UNITED STATES PATENT AND TRADEMARK OFFICE

10/581,612

Office Action Summary	Application No. 10/581,612	Applicant(s) MOGI ET AL.	
	Examiner Tony Chuo	Art Unit 1795

DETAILED ACTION

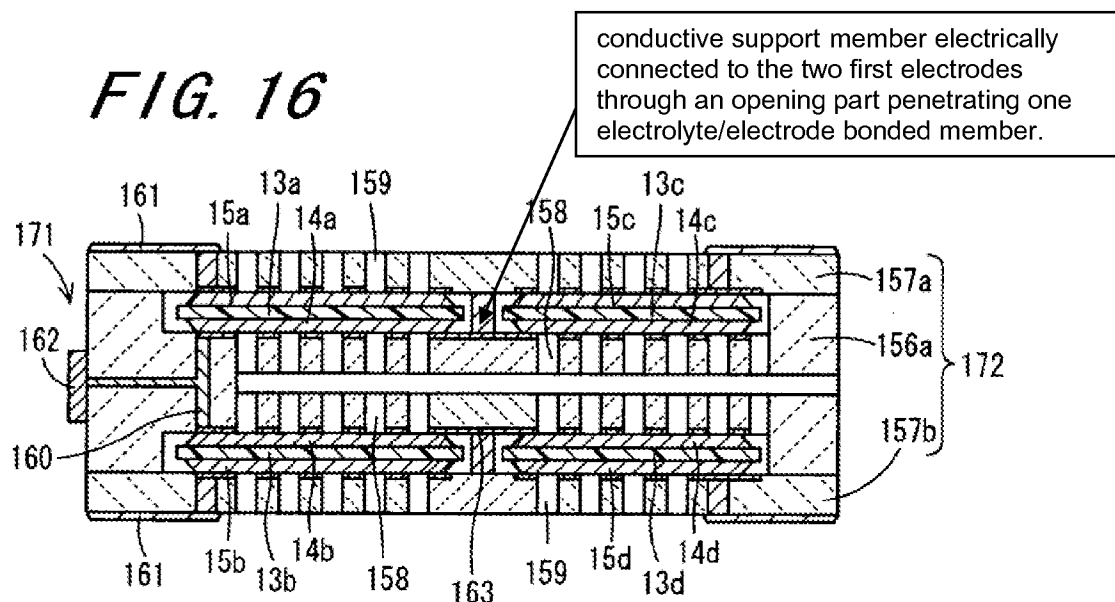
The Sugai reference teaches a conductive support member (see Figure 16 below) that is electrically connected to the two first electrodes "14a" & "14b" through an opening part provided penetrating one electrolyte/electrode bonded member; a second electrode "14a" of a first membrane electrode assembly and a second structural electrode "14b" of an adjacent second membrane electrode assembly that are stacked

so as to face each other via an insulating sealing material "156a", and an conductive support member "164" connected to a first electrode "14a" of a first membrane electrode assembly and a second electrode "15b" of an adjacent second membrane electrode assembly that are electrically connected, whereby the first membrane electrode assembly and the second membrane electrode assembly are connected in series (See Figures 16 and 17).
